**MONTGOMERY
COUNTY NY**

MONTGOMERY COUNTY PLANNING BOARD MEETING

VI. Town of Minden- Site Plan Review

Tessiero Square | Town of Amsterdam | Montgomery County | New York State

C - 161

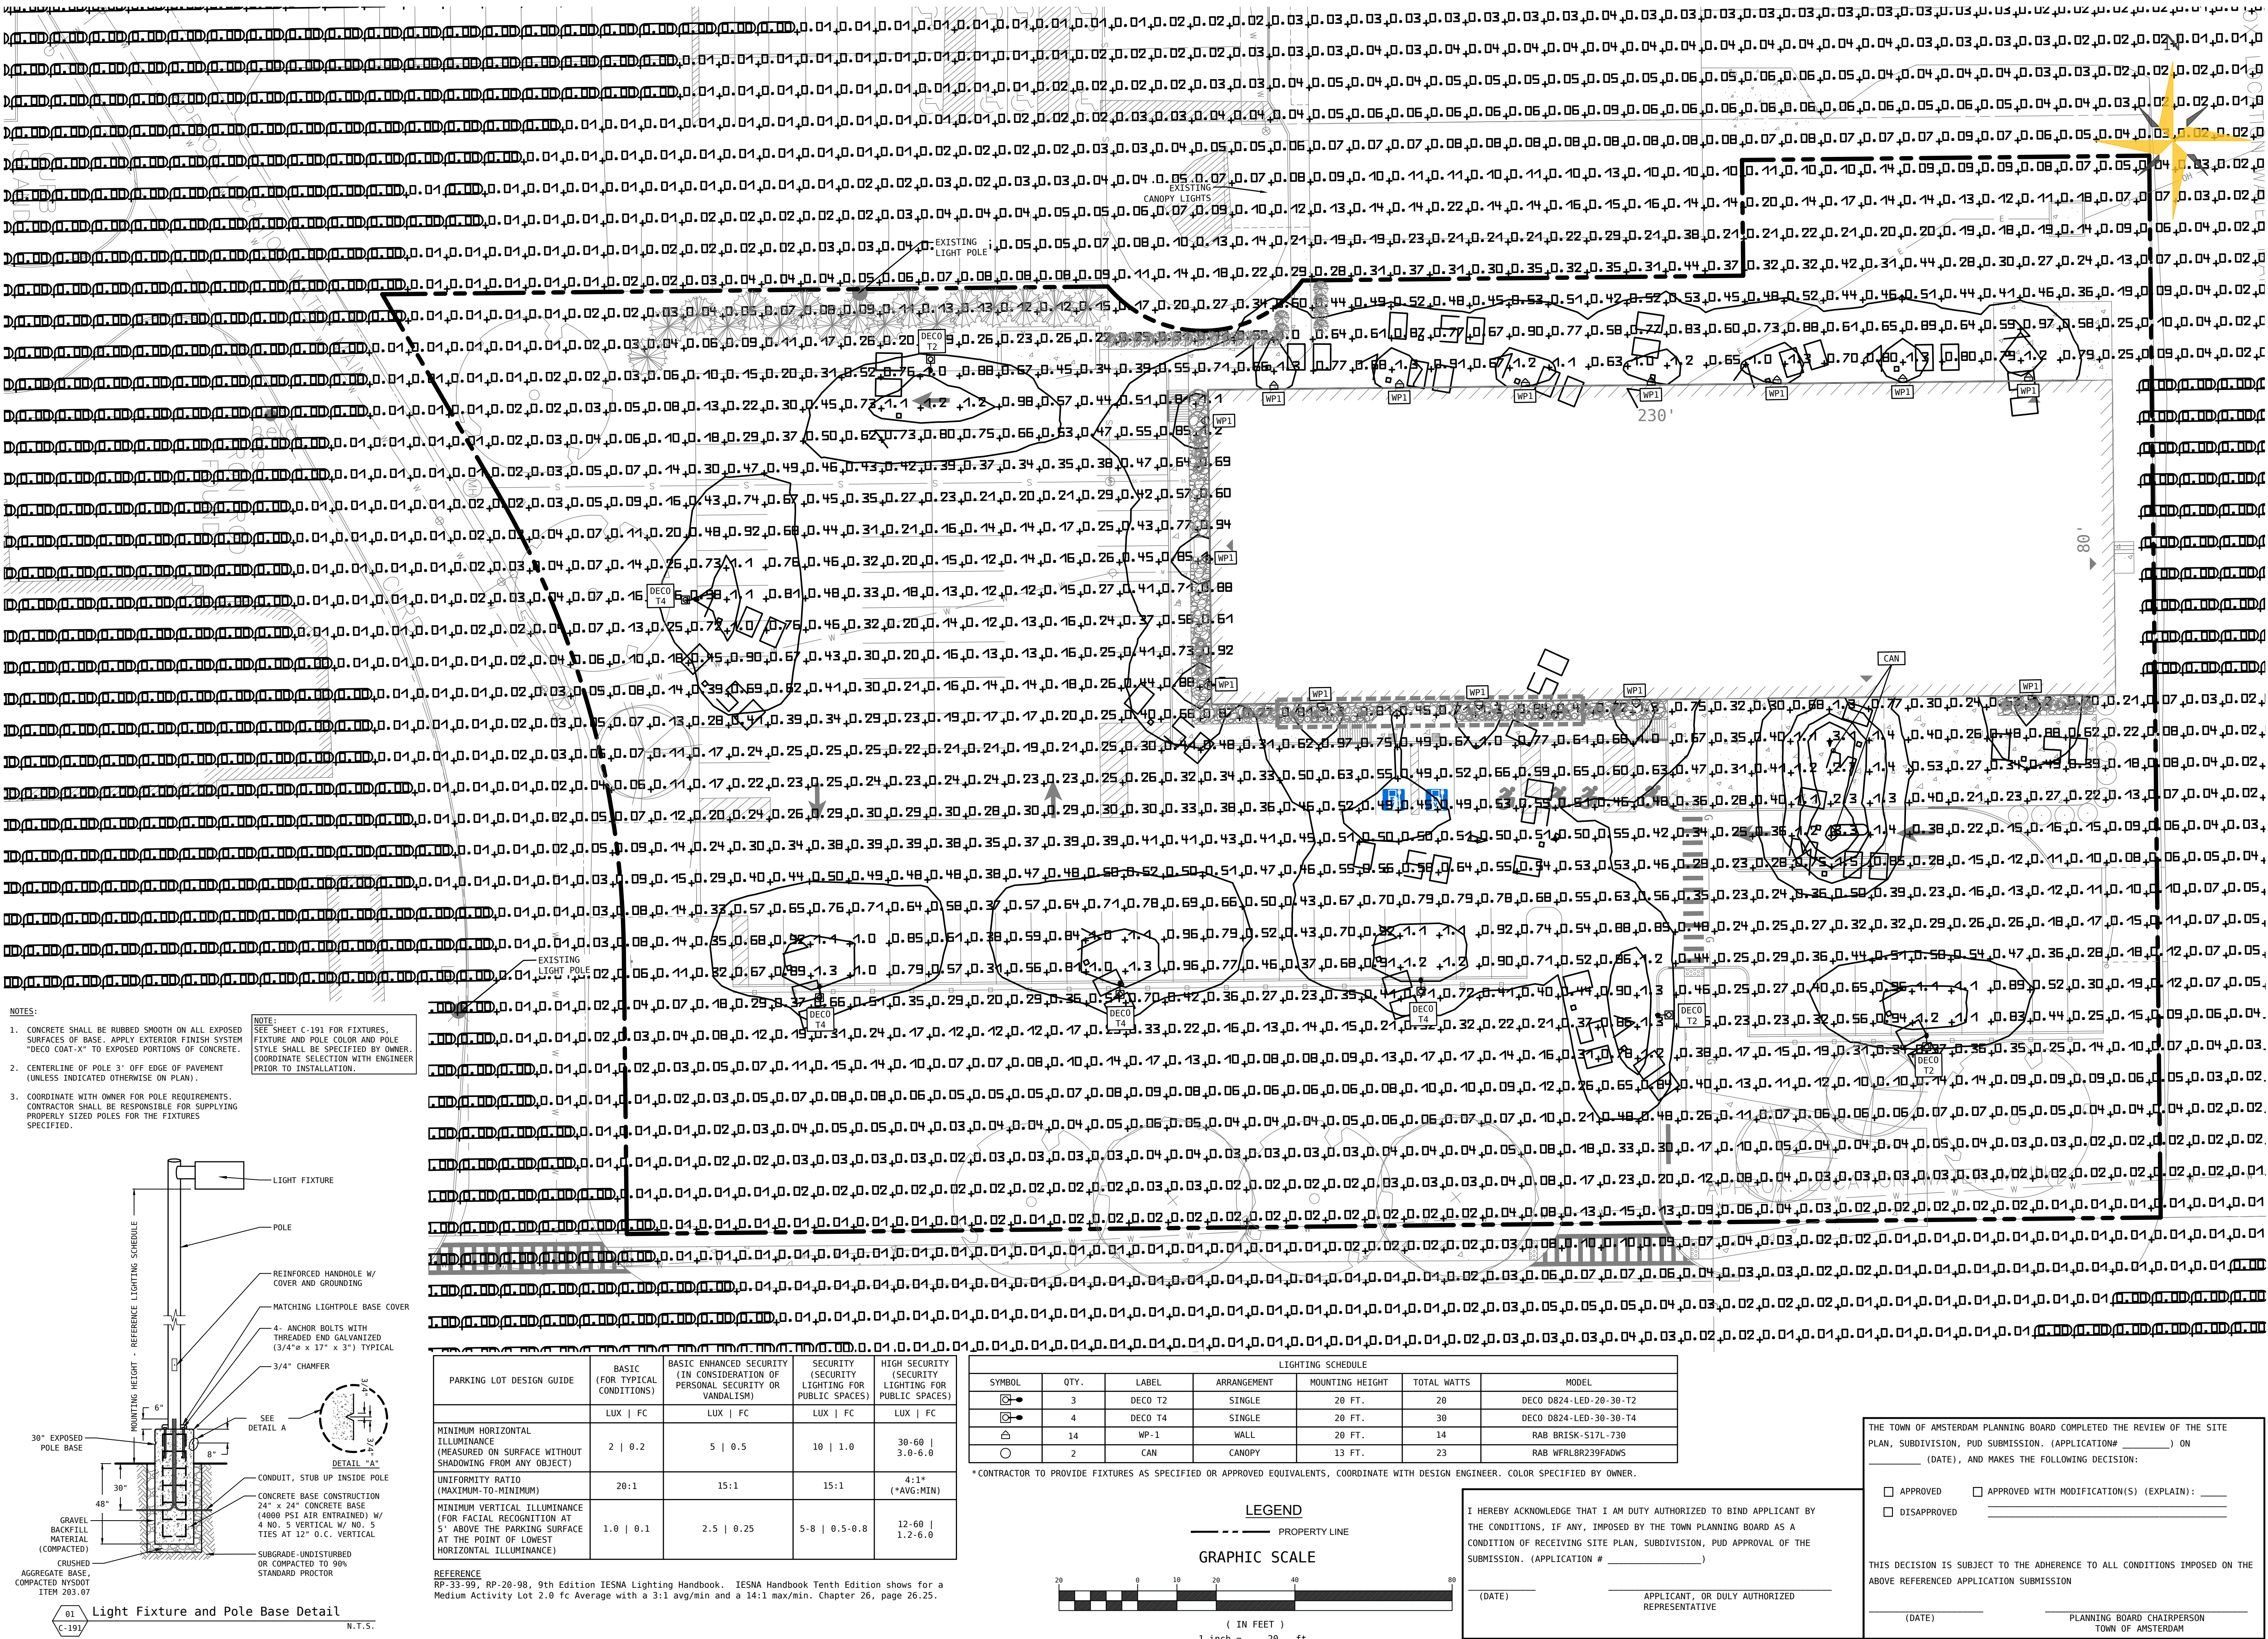
- 13. The sketch plan indicates a proposed sidewalk connection to NY Route 30. In addition to a plan for these offsite improvements, we recommend that the Applicant address the necessary permits (e.g., from the Town and NYSDOT) and property owner permissions required in the next submission.*

A lighting plan has been provided showing proposed exterior lighting and photometrics; please see sheet C-161.
